**FARRAGUT VISUAL RESOURCES REVIEW BOARD
AGENDA**

MEMORANDUM

TO: Farragut Visual Resources Review Board
FROM: Bart Hose, Assist. Community Development Director.
SUBJECT: Regularly Scheduled Meeting - Tuesday, January 25, 2022, at 7:00 p.m.

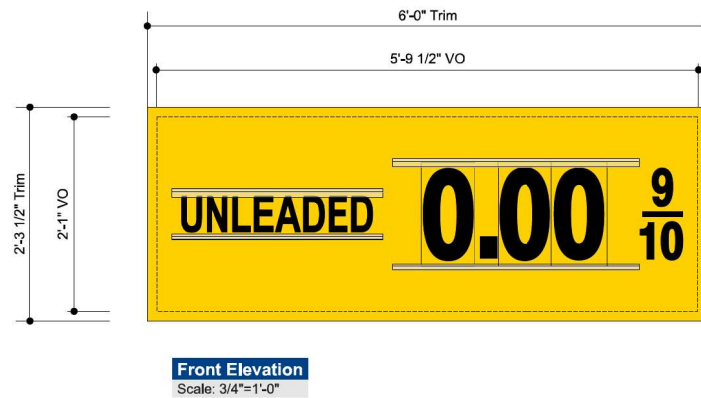
Casey's is requesting approval for a refaced monument ground sign located at 701 North Campbell Station Road.

The plan includes installing a new 28 square foot sign face on an existing sign structure.

1. Revising the site plan sheet to document the sign setback from the property line as opposed to the street edge (previous permit shows a 14-foot setback).
2. Revising the sign plan sheet(s) to document all required sign and structure dimensions more clearly. This would include existing sign base height and height of the address number area.
3. Specifying the use of a dwarf variety Boxwood for the landscaping to avoid future sign visibility conflicts.

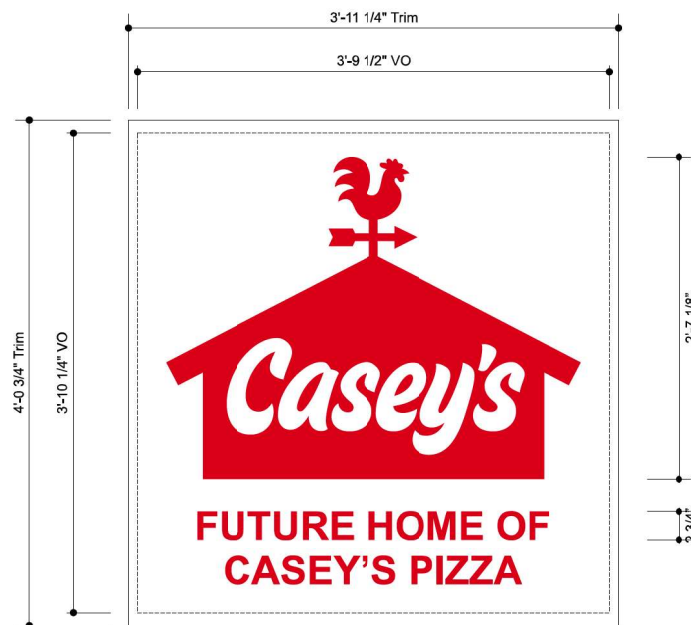
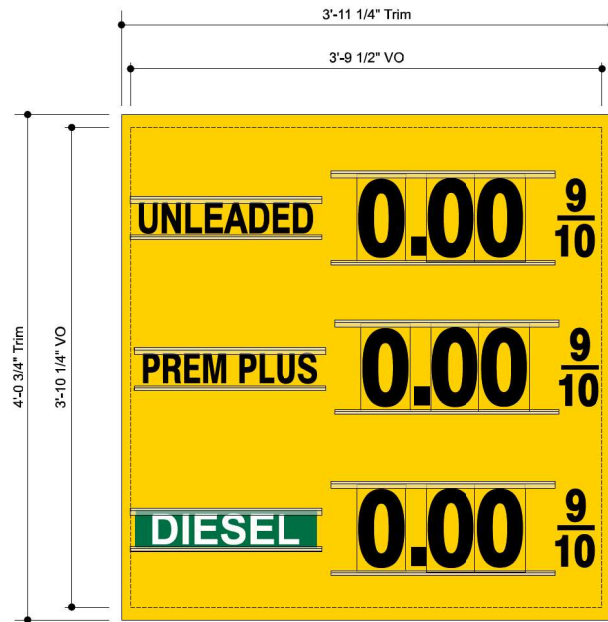
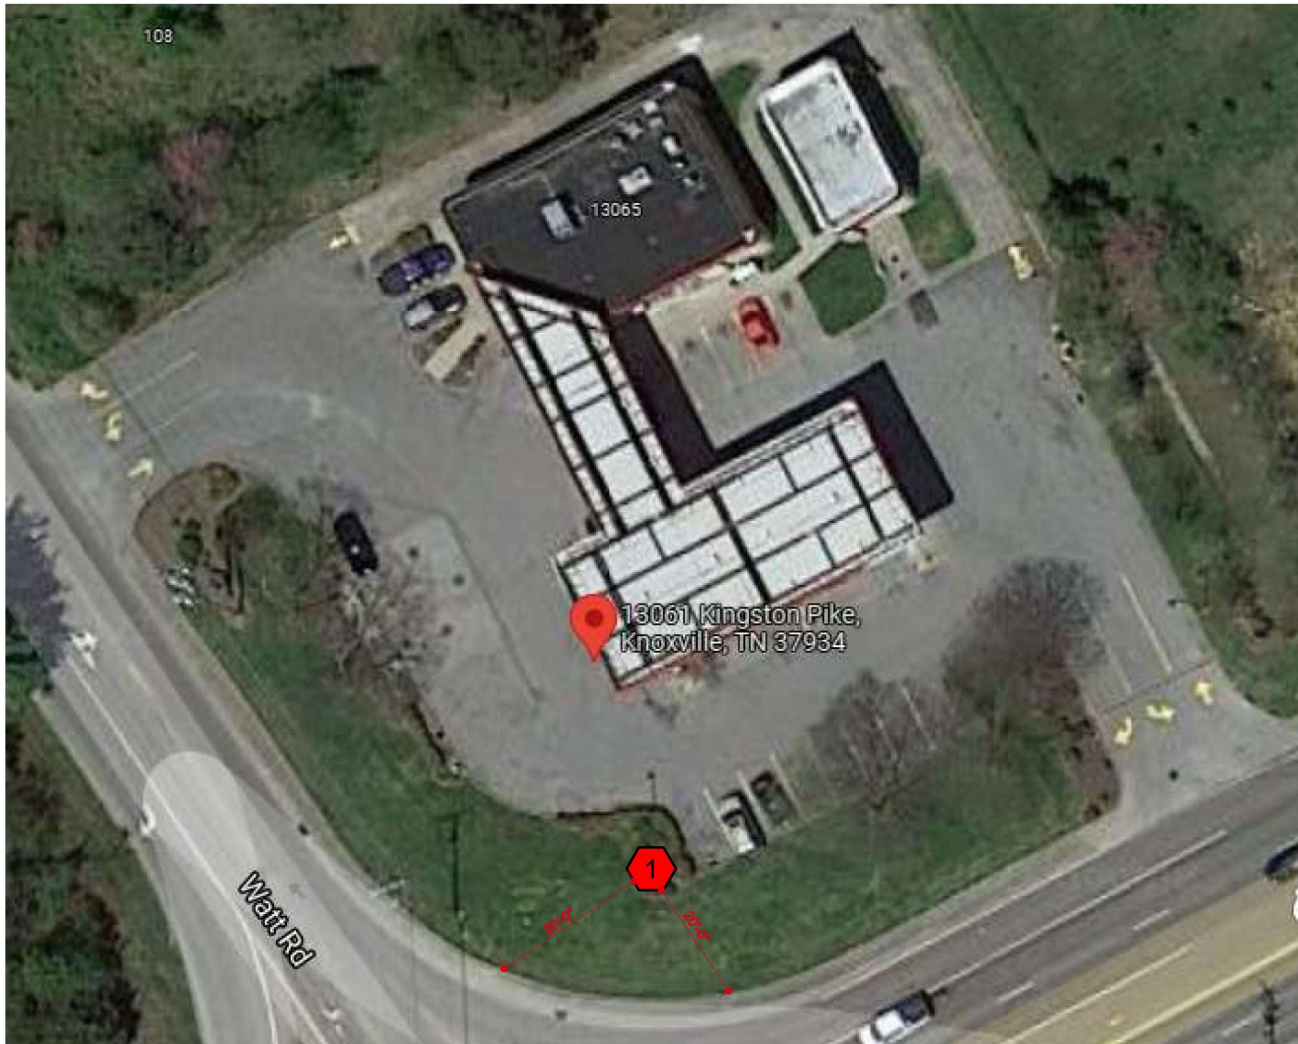
The plan includes installing a new sign face on an existing sign structure. There is some question regarding the total area of the proposed sign face. Previous permits indicate a 16-foot setback for the existing sign structure. This would allow for a sign area of up to 32 square feet.

1. Revising the site plan sheet to document the sign setback from the property line as opposed to the street edge (previous permit shows a 16-foot setback).
2. Verifying sign area and revising the sign plan sheet(s) to clearly document compliant dimensions.

The applicant should also ensure that dwarf variety and noninvasive species are used if any of the existing plants need to be replaced.

NORTH ENTRY SIGN 1 - LAYOUT PLAN
SCALE: 1" = 10'

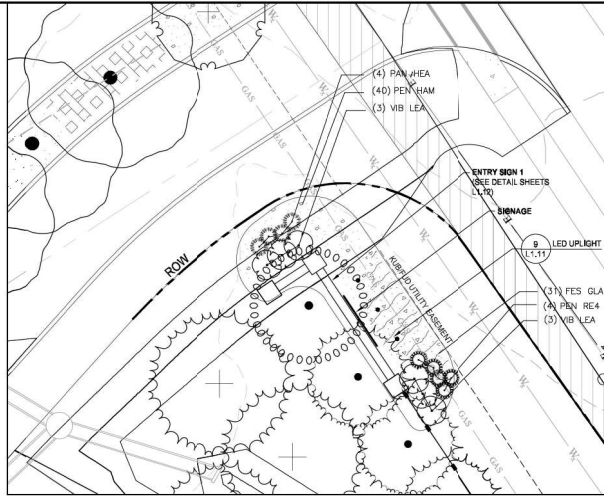
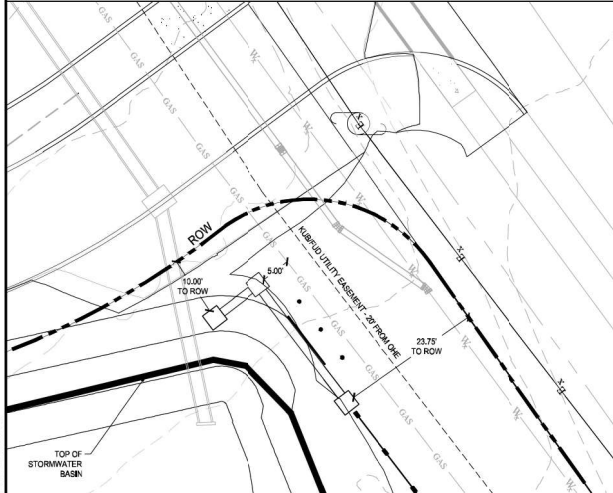
1. Clarifying the final location of utilities and related easements along McFee Rd. and verifying compliance with all setback requirements.
2. A survey being required to document that the installed sign meets all setback and other applicable standards.

SOUTH ENTRY SIGN 2 - LAYOUT PLAN
SCALE: 1" = 10'

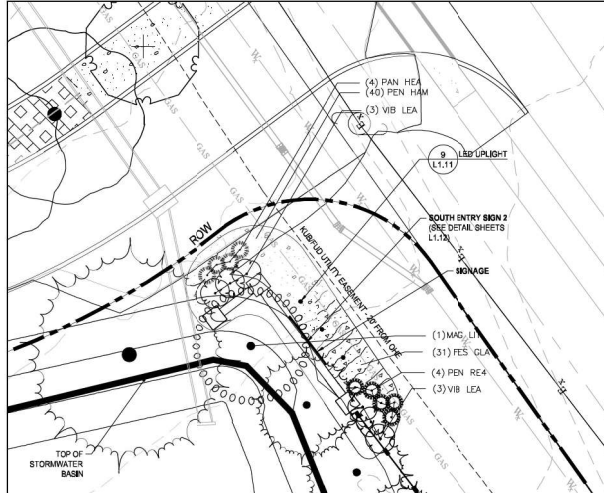
The southern entrance road to this subdivision has been shown on a preliminary subdivision plat but has not yet been constructed. No sign permit will be issued until sufficient progress has been made toward completing construction of the roadway.

1. Clarifying the final location of utilities and related easements along McFee Rd. and verifying compliance with all setback requirements.
2. Verifying the final location of all drainage pipes, structures, and easements; and assuring compliance with any setback requirements.
3. A survey being required to document that the installed sign meets all setback and other applicable standards.

LANDSCAPE PLAN
SKORE HOTEL
11320 Outlet Drive Farragut, Tennessee 37939

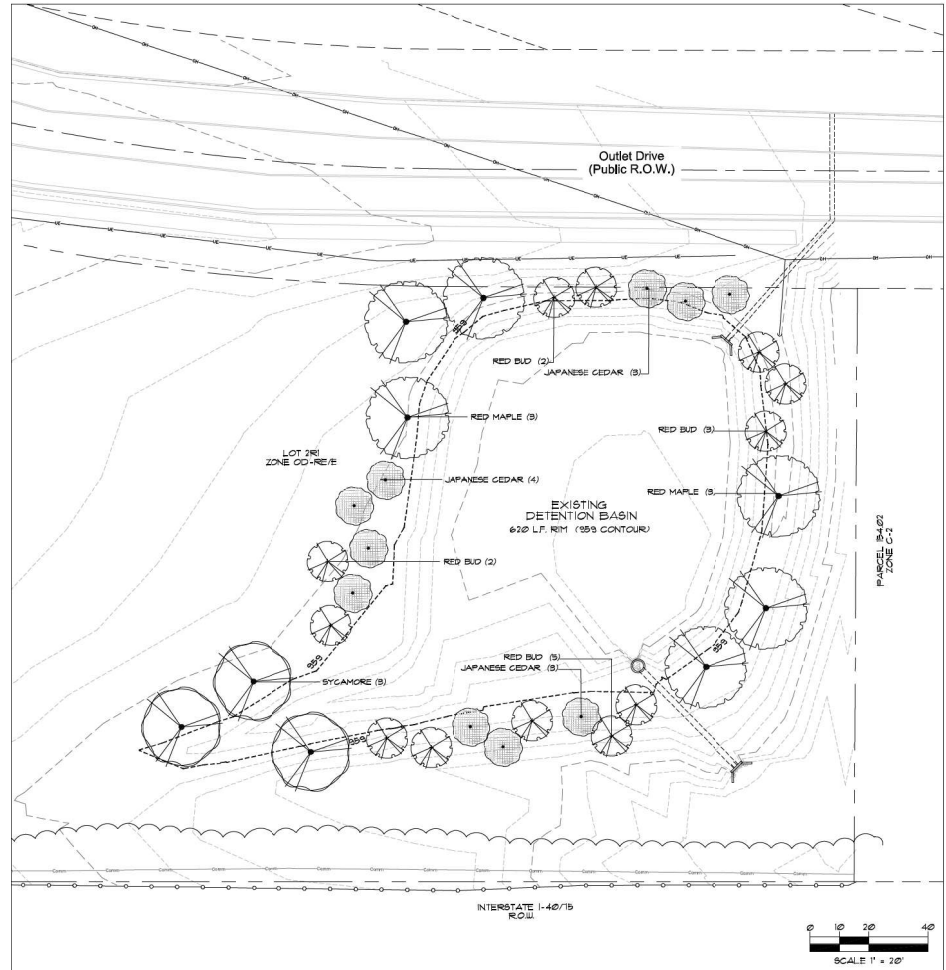
The applicants are requesting approval to utilize Hornbeam trees as shade tree substitutes in areas of close proximity to the building and several light poles. The board may permit this under the ordinance provided such substitutions do not exceed 20% of the total number of required number of shade trees on the site. The plan includes seven Hornbeams, however, only five of them are being substituted for qualifying shade trees.

1. Adding a landscaped island to the southeastern most row of parking as required by the Planning Commission as part of the site plan approval.
2. Adequately addressing landscaping needs for the existing stormwater detention basin on the property. The developers will likely be redesigning this basin in the near future and are working with the Town staff to address the landscaping in this context.
